SUBJECT: Duke Power Company LLC d/b/a Duke Energy Carolinas, LLC
(Duke)
McGuire Nuclear Station, Unit 2
Docket Number 50-370
Relief Request 06-GO-001
Response to Request for Additional Information regarding
Stress Analysis

Responses to Request for Additional Information
Relief Request 06-GO-001 Commitments
McGuire Nuclear Station Unit 2
Duke Energy

REQUEST FOR ADDITIONAL INFORMATION
RELIEF REQUEST 06-GO-001 COMMITMENTS
MCGUIRE NUCLEAR STATION UNIT 2
DUKE ENERGY

Figure 1: Three-Dimensional Finite Element Model for McGuire/Catawba Spray Nozzle

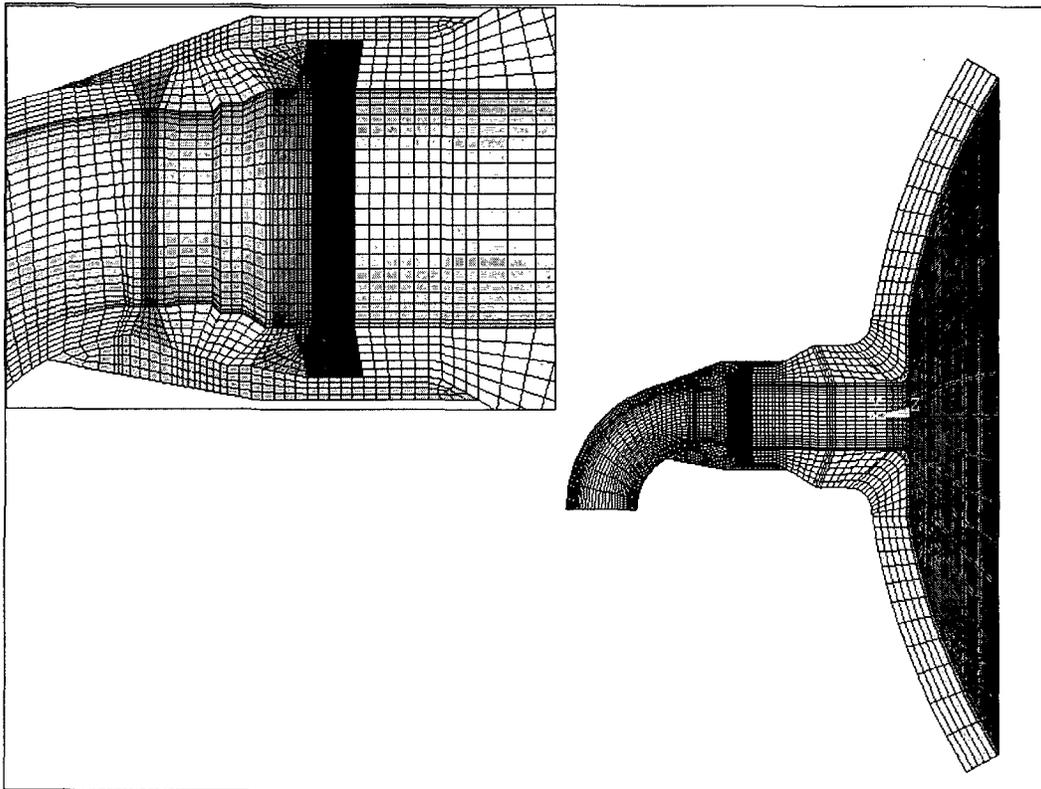
1. The licensee performed stress analysis of the overlaid pressurizer nozzle welds in accordance with Subarticles NB-3200 and NB-3600 of the ASME Code, Section III. The results as shown in Table 2-2, showed that applied stresses of Equation 10 of Subarticle NB-3600 for the overlaid nozzles exceeded the allowable stress. For the spray nozzle, the applied stress (149.09 ksi) calculated based on Equation 10 is 3 times higher than the allowable stress (48.53 ksi). For the safety/relief nozzle welds, the applied stress (67.58 ksi) is about 1.4 times higher than the allowable stress (47.88 ksi). (A) Discuss why the applied stress exceeds the allowable with such high margins after weld overlays. (B) Provide the applied stresses calculated for the original spray and safety/relief nozzle welds without the weld overlay.

- A. The analysis technique for the spray and safety/relief nozzle weld overlays employed detailed three-dimensional finite element models, e.g. Figure 1. Stresses were evaluated on several paths for ASME Code, Section III evaluation, as illustrated in Figure 2 (a total of nine paths were chosen, three at the intrados section of the model, as illustrated in the figure, three at the extrados section, and three at an intermediate location (mid-way between the extrados and intrados, denoted as the "cheek" section). The models predict high elastic primary-plus-secondary stresses at some locations, specifically at the elbow end of the overlay, in the intrados section, on the outside surface (Path 3 in Figure 2). However, a component may still be qualified in accordance with ASME Code, Section III when the $3S_m$ limit on primary-plus-secondary stress range is exceeded, as long as the alternate analysis requirements of NB-3653.6 and NB-3653.7 are satisfied. Such analyses were performed for the McGuire/Catawba spray and safety/relief nozzle weld overlays, and the results were found to be acceptable. The results of these analyses are summarized in the response to Question 3 below.

Figure 3: Though-wall Stress Paths in Residual Stress Model of Surge Nozzle (Typical). Paths 1 through 3 are in the DMW

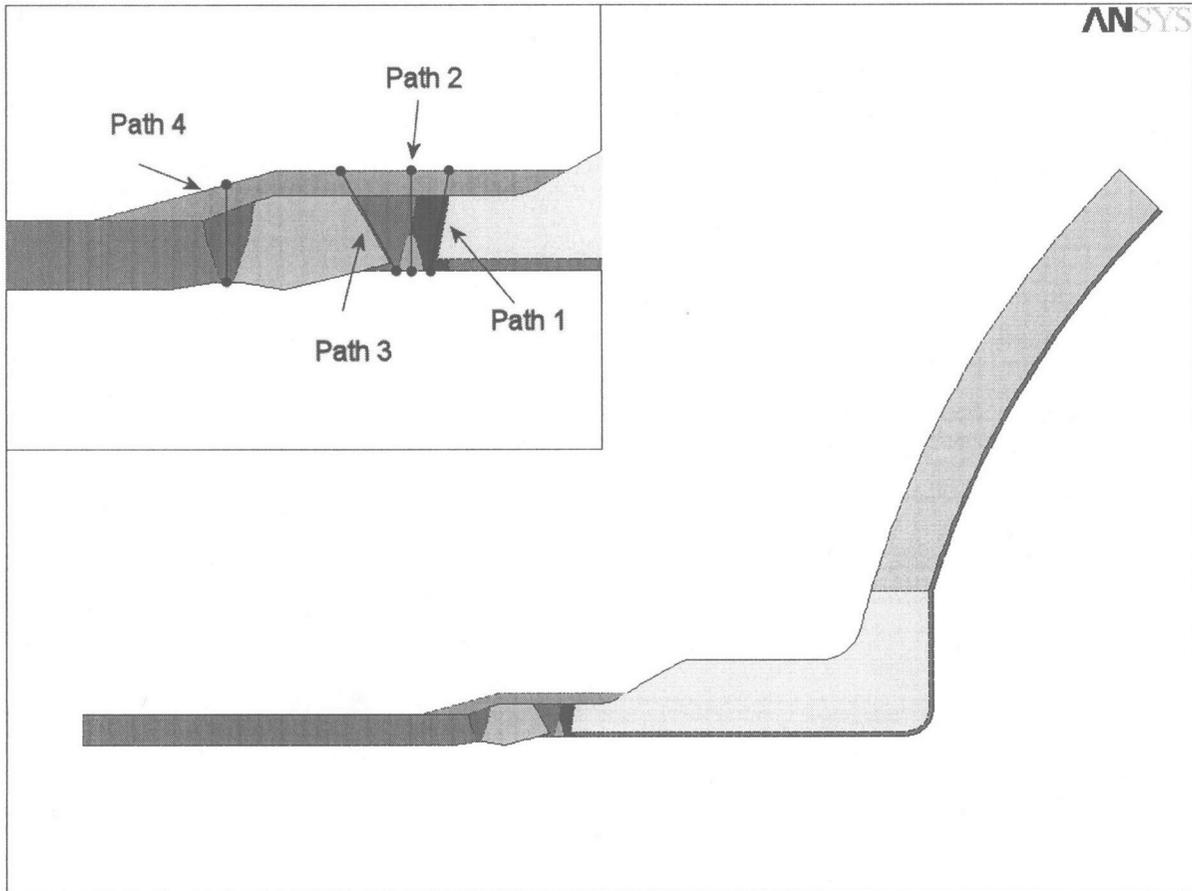
- Figure 2-5 showed the typical residual stress results along (in the longitudinal direction) the inside surface of the original welds. Provide the residual stress profiles (for axial and hoop stresses) along the wall thickness of the original weld and the weld overlay for the spray, surge, and safety/relief nozzles. The staff requests these residual stress profiles to determine the profiles of the tensile and compressive stresses along the wall thickness (in the radial direction).

Nozzle specific residual stress analyses were performed for the McGuire/Catawba safety/relief, spray and surge nozzles using the methodology described in MRP-169. A typical finite element model showing the through-wall stress paths selected for crack growth evaluation is illustrated in Figure 3. Computed post-overlay residual stresses (at operating temperature) along these stress paths are illustrated in Figures 4 through 6. The vertical dashed lines in these figures represent the boundary between the original dissimilar metal welds (DMWs) and the overlays.

Figure 7: Surge Nozzle Stress Intensity Factors due to Sustained Operating plus Residual Stresses along Limiting Crack Path in DMW – Plant-specific to McGuire/Catawba

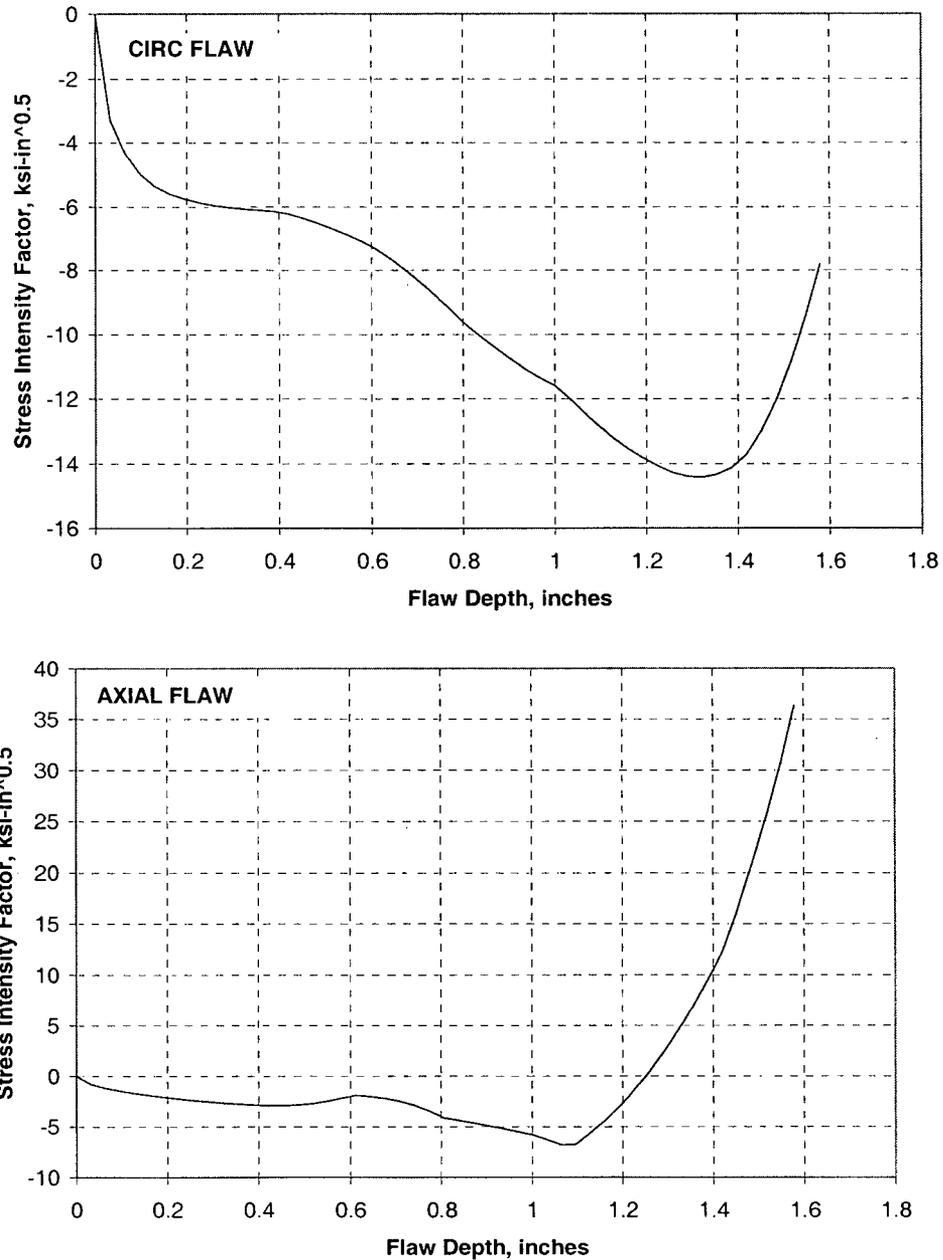
6. Page 5, third paragraph. The licensee stated that PWSCC crack growth is zero because the stress intensity factors remained negative for crack depth up to and beyond 75 percent of the original weld wall thickness (the crack initiates from the inside surface of the pipe and grows 75 percent of the wall thickness). In MRP-169, the residual stress profile of typical pressurizer nozzles showed that the axial stress changed from being compressive to tensile at about 50 percent of weld wall thickness. This means that a PWSCC crack may grow if its depth is more than 50 percent through wall. The licensee's statement contradicts the results of residual stresses in MRP-169. Provide results of stress profiles to support that PWSCC crack does not grow beyond 75 percent through wall.

The post weld overlay residual stress profiles illustrated in Figures 4 through 6 above were combined with pressure stresses and other sustained loads during normal operation, and input to fracture mechanics models applicable to the nozzle and assumed flaw geometries. These stress profiles were developed specifically for the plant-specific McGuire/Catawba nozzle configurations, and the MRP-169 results were not utilized. It is Structural Integrity's opinion that residual stress analyses should be performed on a plant-specific basis as opposed to utilizing the sample plant results in MRP-169. For circumferential flaws, the fracture mechanics model consisted of a 360° flaw in a cylinder with a thickness-to-inside radius ratio, t/R_i , varying from 0.2 to 0.46 (nozzle specific). For axial flaws, an elliptical inside surface flaw with an aspect (depth-to-length) ratio of 0.2 in an infinite flat plate was used. The 0.2 aspect ratio is conservative because for deep flaws (for example 75% through-wall in the DMW) the crack length on the inside surface associated with this flaw assumption would be > 5 inches, which is longer than the length of PWSCC susceptible material on the inside surface. The flat plate assumption is also conservative since the cylindrical pipe/nozzle geometry is stiffer, and thus more resistant to crack opening than a flat plate. The resulting sustained stress intensity factors for normal operation are shown in Figures 7, 8 and 9. Residual stresses for these analyses were chosen for the most limiting of Paths 1, 2, and 3 in Figures 4, 5 and 6.

Note that the stress intensity profiles remain compressive to a depth beyond the point at which the stresses transition from compressive to tensile. This is because the fracture mechanics models integrate the stresses over the entire crack front to determine K, not just the stress at the crack tip.
